ADDENDUM NO. 01

INFORMAL BID NO. 09-I007-J30

IT Server Room Wire Management, Yuba College

Addendum 01: December 9, 2009
Bid Opening: December 14, 2009, 10:00:00 am
Project Location: **Yuba College Campus**

ELECTRICAL SYMBOLS AND ABBREVIATIONS - E0.1

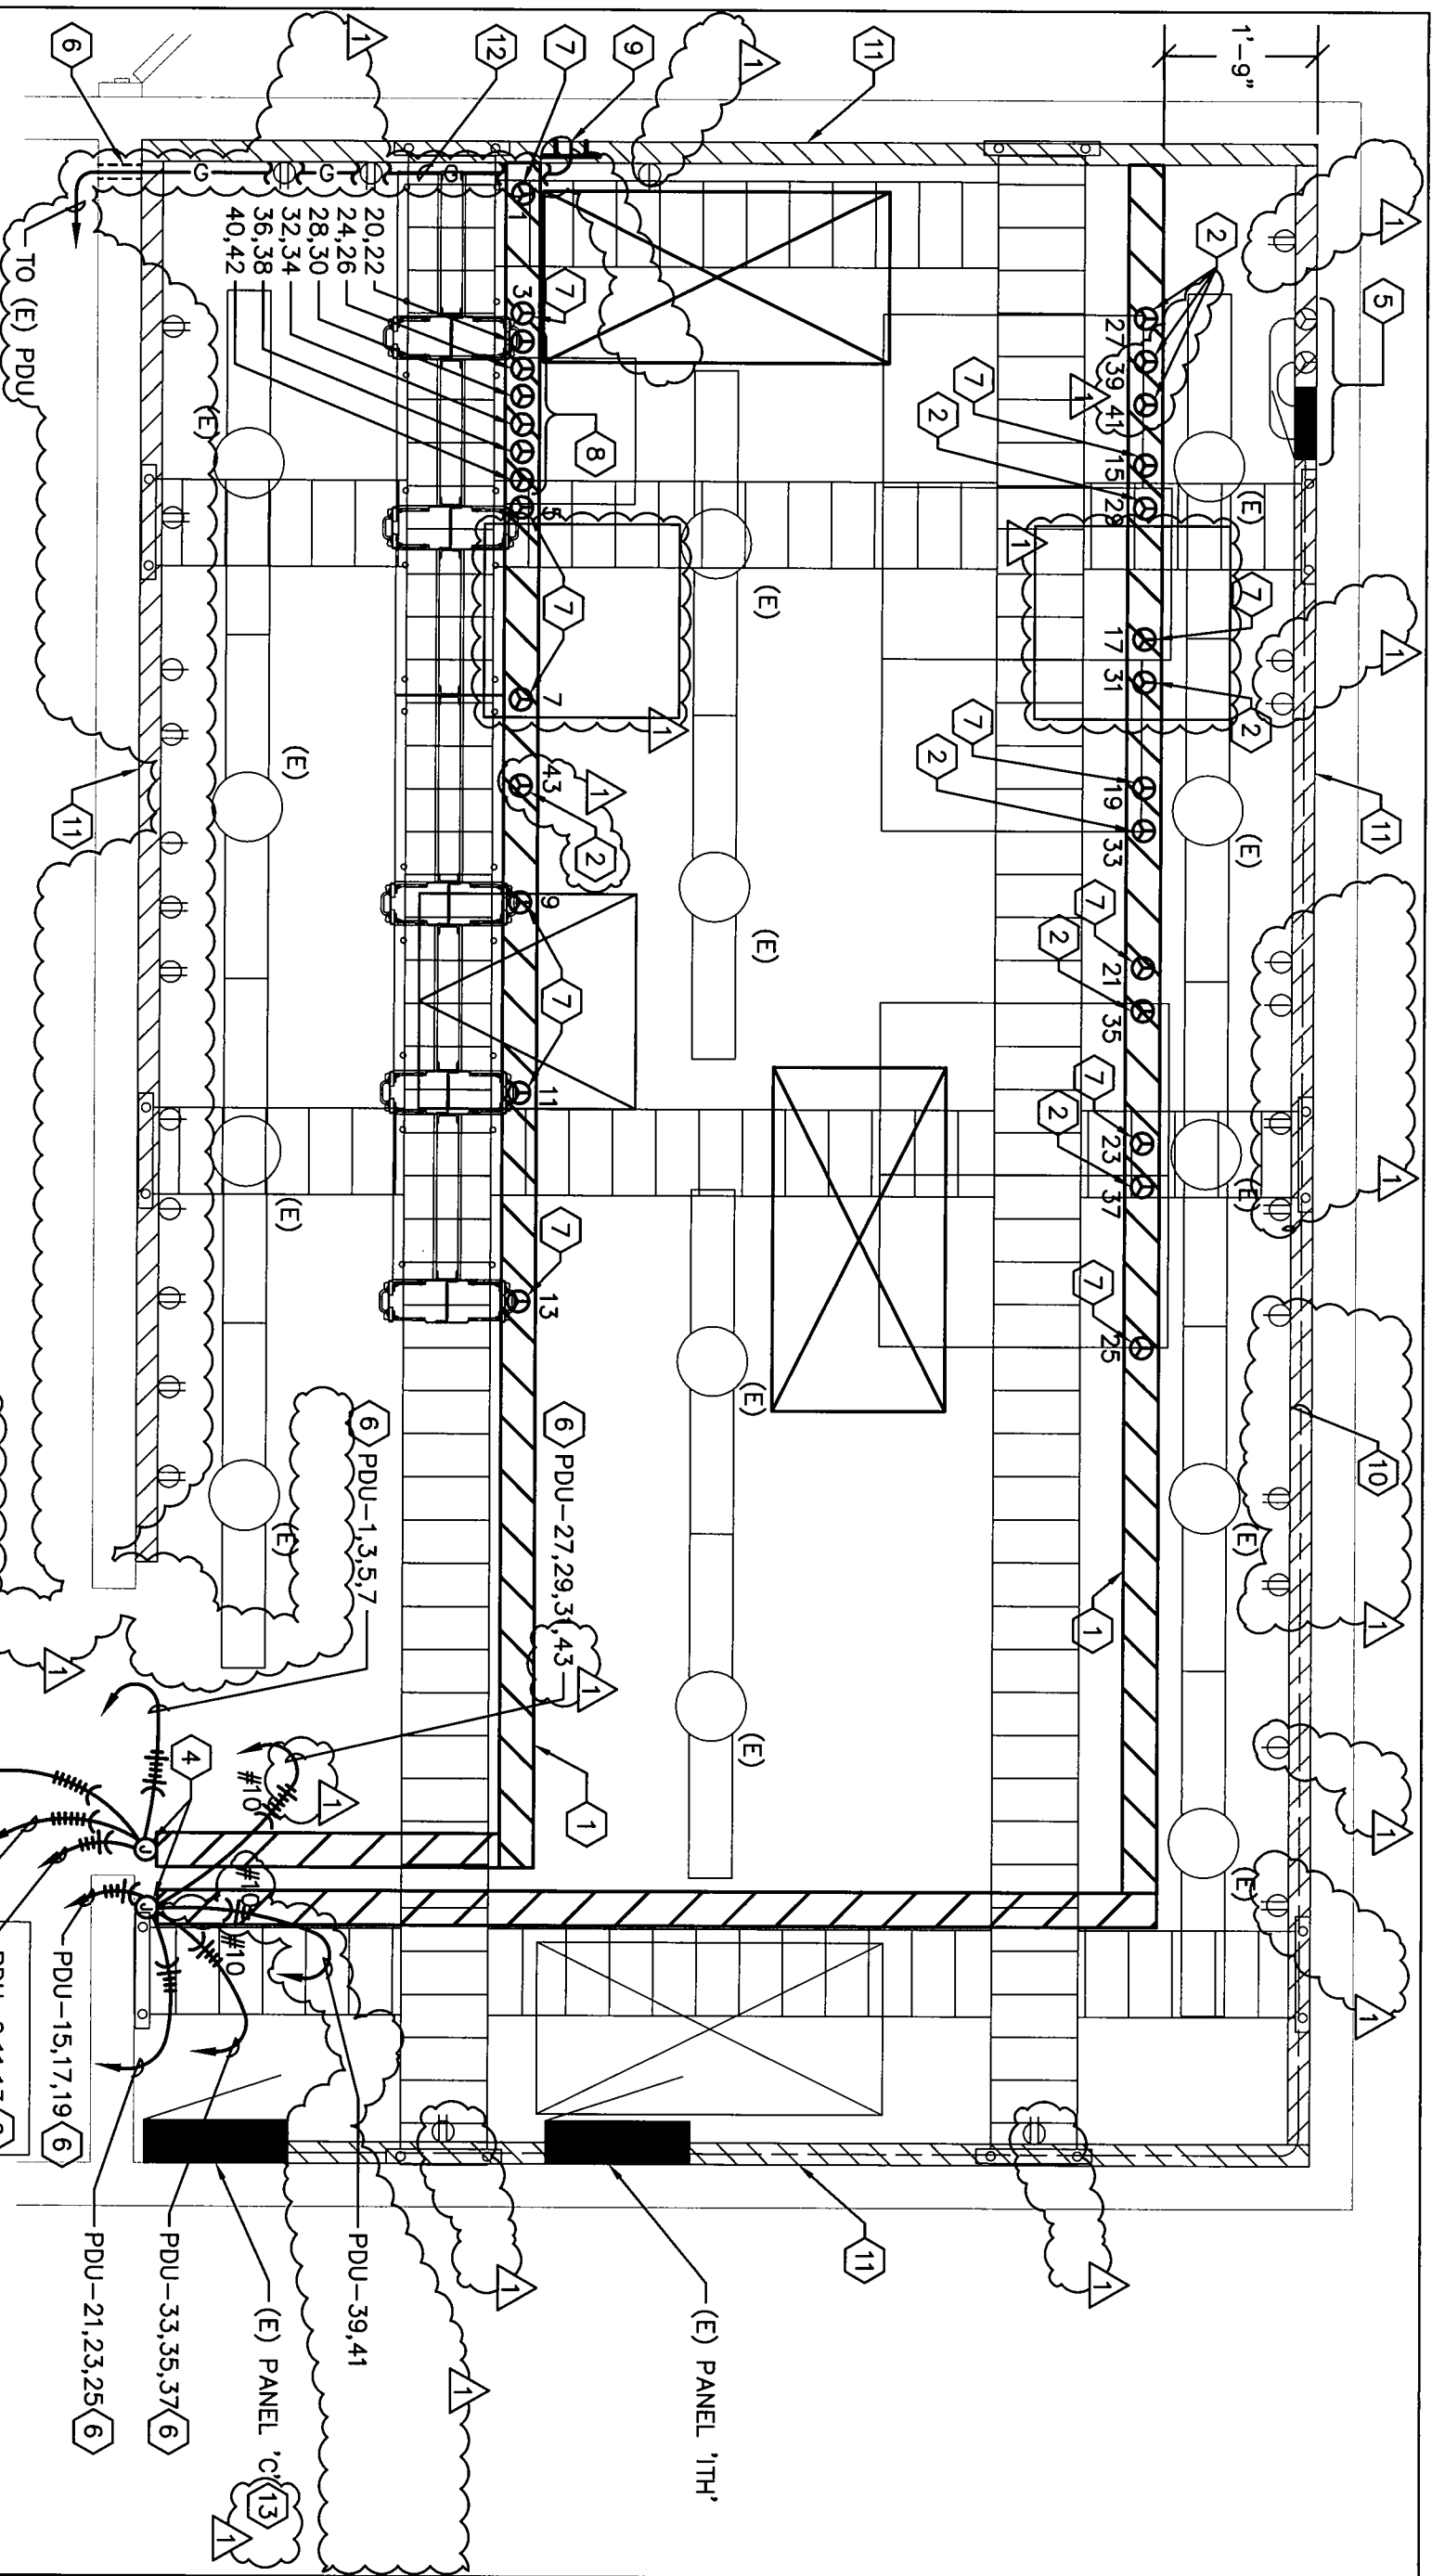
1. Sheet E0.1 (See addendum drawing AD01-E01)
 - a. Delete panel schedule for existing Panel C.
 - b. Revise circuits and load information in the schedule for existing Panel PDU.
2. Sheet E3.1 (See addendum drawing AD01-E02)
 - a. Delete Sheet Keynotes 14 through 19 on the Enlarged Floor Plan.
 - b. Added (2) 30A, 125V twist lock receptacles to the ceiling mounted surface wire way above the equipment rack in the northwest corner of the space.
 - c. Added (1) 30A, 125V twist lock receptacle to the ceiling mounted surface wire way above the phone switch equipment rack.
 - d. Deleted the re-circuiting of the existing receptacles located in the existing surface wire way that runs around the room, low on the wall.

(E) Panel 'PDU'		120/208V, 3 Ph., 4 W. Surface Mounted, Lighting & Appliance Branch Panelboard										
		200A Bus with Main Lug Only / Available Fault: 8087A RMS										2009-0234.01
Ckt. No.	Description / Location	Load (VA) Type	C.B. A/Pole	Note	Ph.	Note	C.B. A/Pole	Load (VA) Type	Description / Location	Ckt. No.		
1	SERVER ROOM TWISTLOCK RECEPT.	1,920 R	20/1		A		150/3	15,000 S	(E) PANEL 'C'	2		
3	SERVER ROOM TWISTLOCK RECEPT.	1,920 R	20/1		B		---	15,000 S	---	4		
5	SERVER ROOM TWISTLOCK RECEPT.	1,920 R	20/1		C		---	15,000 S	---	6		
7	SERVER ROOM TWISTLOCK RECEPT.	1,920 R	20/1		A		60/3	640 S	(E) PANEL 'T'	8		
9	SERVER ROOM TWISTLOCK RECEPT.	1,920 R	20/1		B		---	640 S	---	10		
11	SERVER ROOM TWISTLOCK RECEPT.	1,920 R	20/1		C		---	640 S	---	12		
13	SERVER ROOM TWISTLOCK RECEPT.	1,920 R	20/1		A		20/1	180 R	(E) ROOF RECEPTACLE	14		
15	SERVER ROOM TWISTLOCK RECEPT.	1,920 R	20/1		B		20/1	694 M	(E) REF-2	16

- DISCONNECT AND REMOVE SUB-FEED TO (E) PANEL 'C' AFTER ALL (E) CIRCUITS HAVE BEEN RE-ROUTED, EXTENDED AND CONNECTED TO PANEL 'PDU'.
- (E) LOADS RE-LOCATED FROM (E) PANEL 'C'. CONTRACTOR SHALL LOCATE AND INTERCEPT (E) CIRCUIT CONDUCTORS AT A CONVENIENT LOCATION AND EXTEND AS NECESSARY.

ENLARGED FLOOR PLAN - SERVER ROOM - POWER - E3.1

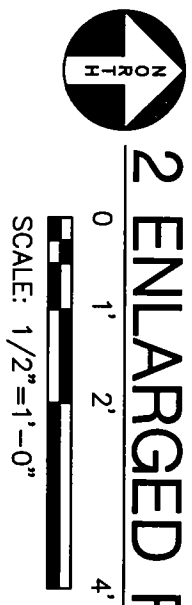
- e. Clarified the routing of the ground conductor from the ground bus bar to the existing Panel PDU.
- 3. Sheet E3.1 (See addendum drawing AD01-E03)
 - a. Delete Sheet Keynotes 14 through 19.
 - b. Revise Sheet Keynotes 12 and 13.

Question: Could you tell me where the PDU is located?

Answer: The location of the PDU (power distribution unit) is shown on Sheet E3.1, "2 ENLARGED FLOOR PLAN – SERVER ROOM – POWER", Keynote #3. It is located in the room you walk through to get into the Server Room. It is located exactly as shown on the plan, it is against the wall separating the two rooms, just to the right of the door between the room, a few feet from (E) Panel "C".

- 1 PROVIDE SURFACE WIREWAY ON CEILING. WIREMOLD 4000 OR APPROVED. PROVIDE WITH WIRE CLIPS TO HOLD CONDUCTORS IN PLACE.
- 2 PROVIDE 30A, 125 VAC TWISTLOCK RECEPTACLE IN SURFACE WIREWAY, NEMA L5-30R.
- 3 PROVIDE NEW CIRCUIT BREAKERS IN THE EXISTING PDU. SEE (E) PANEL 'PDU' SCHEDULE ON SHEET E0.1.
- 4 6"X4"X4" J-BOX.
- 5 (E) 100A BRANCH PANEL BOARD WITH (2) 30A RECEPTACLES TO BE REMOVED.
- 6 CORE DRILL THROUGH (E) CONCRETE WALL AS NECESSARY.
- 7 PROVIDE 20A, 125 VAC TWISTLOCK RECEPTACLE IN SURFACE WIREWAY, NEMA L5-20R.
- 8 PROVIDE 20A, 250 VAC TWISTLOCK RECEPTACLE IN SURFACE WIREWAY, NEMA L6-20R.
- 9 GROUND BUS BAR. PROVIDE #3/0 CU GROUND CONDUCTOR FROM BUS BAR TO MAIN GROUND BUS IN (E) PANEL 'PDU'. SEE 3/T1.5.
- 10 (E) 1-1/2" CONDUIT AND CONDUCTORS TO BE REMOVED.
- 11 (E) SURFACE WIREWAY AND RECEPTACLES ON WALL TO REMAIN.

-  12 #3/0 TO PDU GROUND BUS.
- 13 DURING CONSTRUCTION PHASE OF WORK THAT ALLOWS FOR THE SERVER EQUIPMENT TO BE DE-ENERGIZED. CONTRACTOR SHALL REMOVE THE EXISTING MAIN CIRCUIT BREAKER AND INSTALL LANDING LUGS IN ITS PLACE AND RE-ENERGIZE.
